**City of West Linn**  
**PRE-APPLICATION CONFERENCE MEETING**  
**SUMMARY NOTES**  
January 6, 2011

**SUBJECT:** 8-lot single-family planned unit development (PUD) subdivision at 1555 6<sup>th</sup> Ave., requiring Water Resources Area permit and possibly other permits

**Project #:** PA-10-35

**Metro Habitat Conservation Areas (HCAs) are in green, orange is “Allow Development” area per Metro. White areas are unclassified by Metro.**

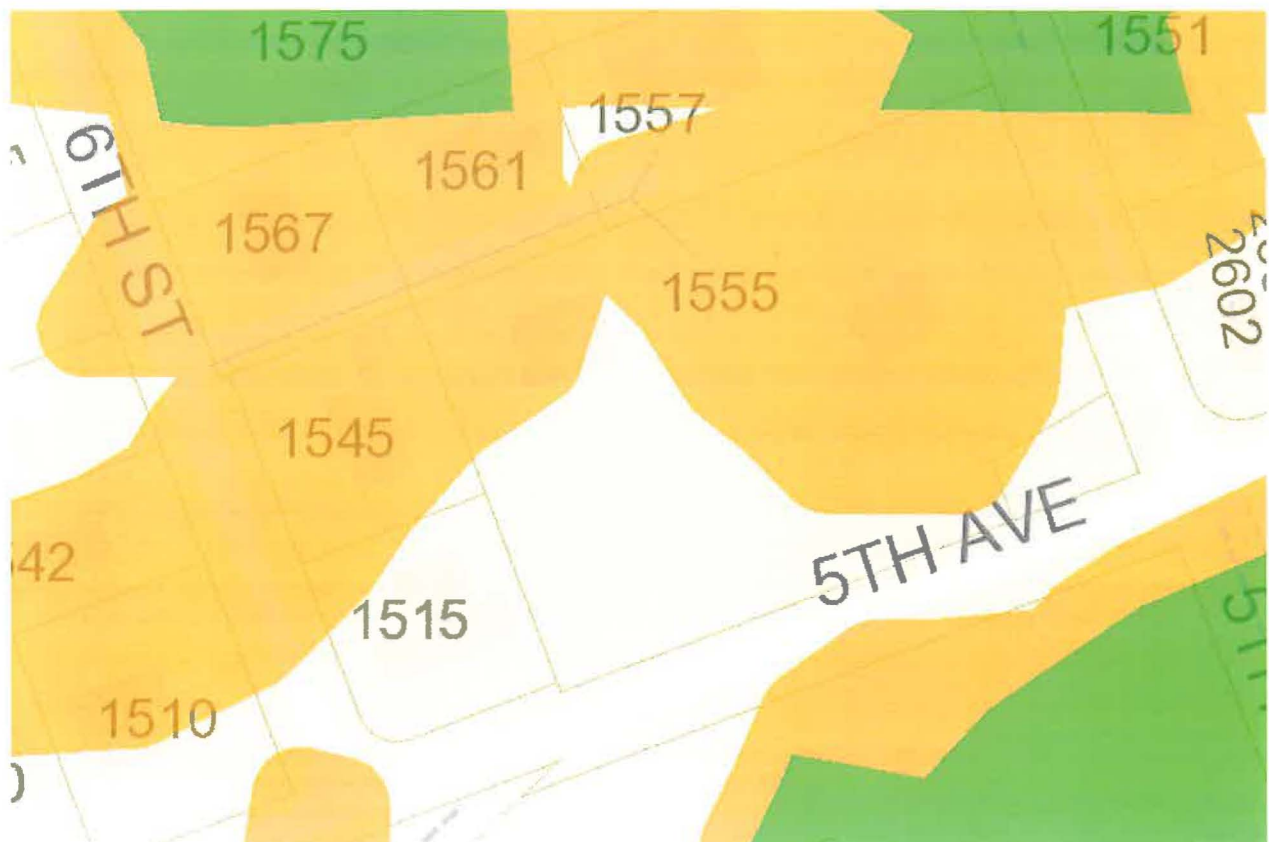
Although it is a few blocks uphill from the Willamette River, the Willamette River Greenway overlay does encompass the site. Whether any given project within this overlay requires a Willamette River Greenway permit now depends heavily on whether there will be development within the Habitat Conservation Areas (HCAs) designated by Metro, per the provisions of CDC Chapter 28. The only part of the site located in a Habitat Conservation Area is the northeast corner of the site, where a triangle of approximately 15 by 30 feet is located in a Habitat Conservation Area. See the map below.

CDC 28.030(S) states, “In cases where the required development standards of this chapter are applied and met with no encroachment into HCAs... then no permit under the provisions of this chapter will be required. For example, if the proposed development or action will be located in the ‘Not Affected by Recommendations’ or ‘Allow Development’ area and keeps out of the habitat conservation areas, a Willamette or Tualatin River Protection Area permit shall not be required.” Therefore if no development occurs on said triangle (even if it is part of one of the lots) than the Willamette River Greenway permit will not be necessary. If the applicant did plan to develop in the said triangle and applied for a Willamette River Greenway permit, the permit and the plan to develop in the triangle would become moot in most situations under the provisions of the permit itself, as one of the criteria (CDC 28.110(H)[2]) states, “Applicant shall partition or subdivide the site so that all parcels have a buildable site or envelope available for home construction located on non-HCA land or areas designated ‘Not Affected by Recommendations’ or ‘Allow Development’ per the Metro HCA map.” Since this is a PUD the applicant can presumably propose to design the lot lines and possibly modify the setbacks if necessary to ensure all development stays out of the HCA. However, if the applicant determines that some development has to occur in said triangle in order to reasonably develop the lot at the northeast corner, this is addressed in criterion 28.110(H)(3) which states, “Development of HCA-dominated lands shall be undertaken as a last resort. A planned unit development (PUD) of Chapter 24 CDC may be required.” If the applicant determines that part of the triangle needs to be developed or landscaped for this lot and wants to make the case that this is necessary to develop this PUD, the applicant shall also submit a Willamette River Greenway permit along with the other required permits discussed above, and follow the submittal requirements of Chapter 28.

**Greenish brown- wetland; Purple hatched area- approximate wetland transition area; Grey- 25%+ slopes**

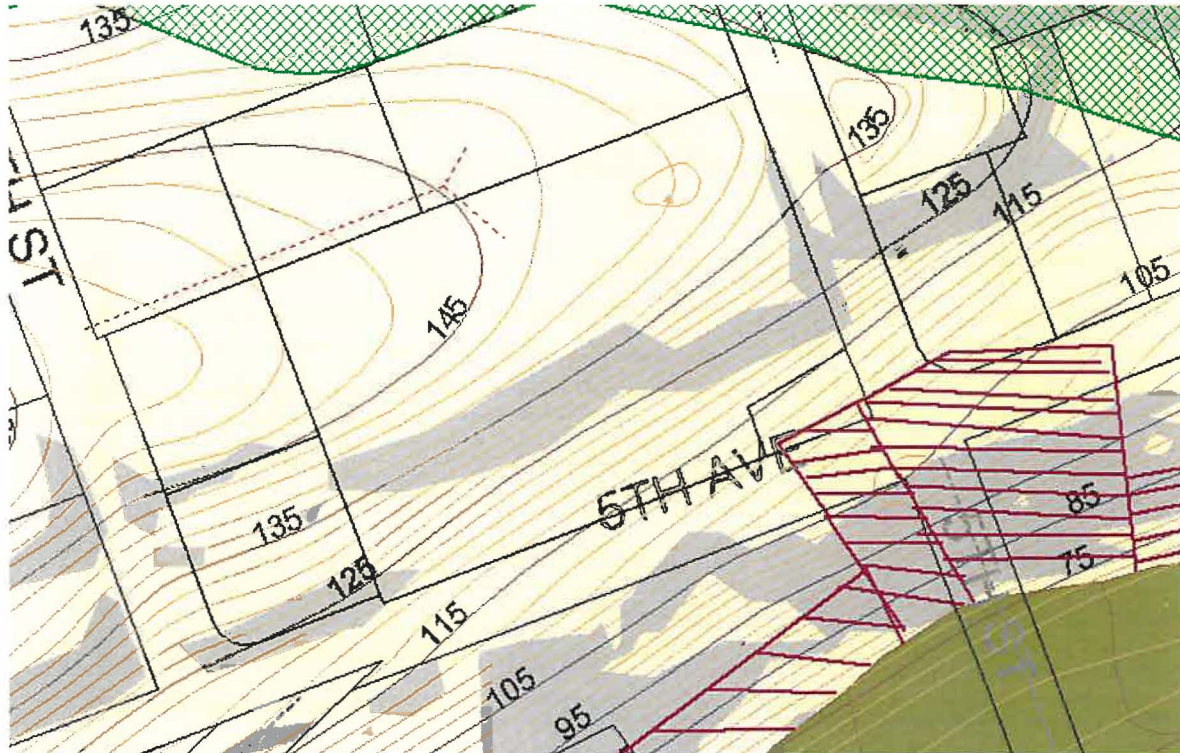
There is a wetland downhill from the site across 5<sup>th</sup> Avenue. For wetlands the transition area (not counting 15-foot extra structural setback) is a) 50 feet if slopes immediately adjacent are less than 25%, b) 50 feet from the top of the ravine, when there are 25% or greater slopes to a distinct top of the ravine, or c) 200 feet when the adjacent slopes are 25% or greater without a distinct top of ravine. Per City GIS, directly downhill from the east end of the site the slopes immediately adjacent the wetland are 25% or greater all the way to 5<sup>th</sup> Avenue itself (which then acts as the top of the ravine). Therefore the transition area should be measured starting on the south side of 5<sup>th</sup> Avenue where the slope flattens out for the street. This appears to slightly encompass the southeast corner of the site per GIS. The remainder of the wetland edge as one moves west does

not have 25% or greater slopes immediately adjacent per GIS and therefore the transition area is only 50 feet, not affecting the site since the wetland is 100 feet or more away.

Therefore, unless a survey commissioned by the applicant proves differently, the transition area for the wetland overlaps the site's boundaries, albeit in a small area in the southeast corner of the site. However a Water Resource Area permit is needed if any of a site proposed for land division overlaps with a water resource's transition area. See the map below for the staff measurements on GIS discussed above. The significant riparian corridor Bernert Creek lies less than a block north of the site, but per Table 32-1 measurements the site is completely outside the transition area for Bernert Creek and its associated corridor.

Judging by the conceptual site plan submitted for this pre-application conference, the area where the transition area and the site overlap is not likely to have contained development of the houses or driveways. However a Water Resources Area permit is required regardless, and street improvements will likely have to be done in this area. Any new improvements where none existed before will have to be mitigated for (with surrounding temporarily disturbed areas within the transition area revegetated for). Any remaining transition area outside the right of way will have to be placed in a conservation easement or an open space tract, preferably dedicated to the city. Fee simple dedication is preferred per 32.050(D). The applicant shall submit a Water Resource Area permit along with the other permits discussed above, and follow the submittal requirements of Chapter 32.
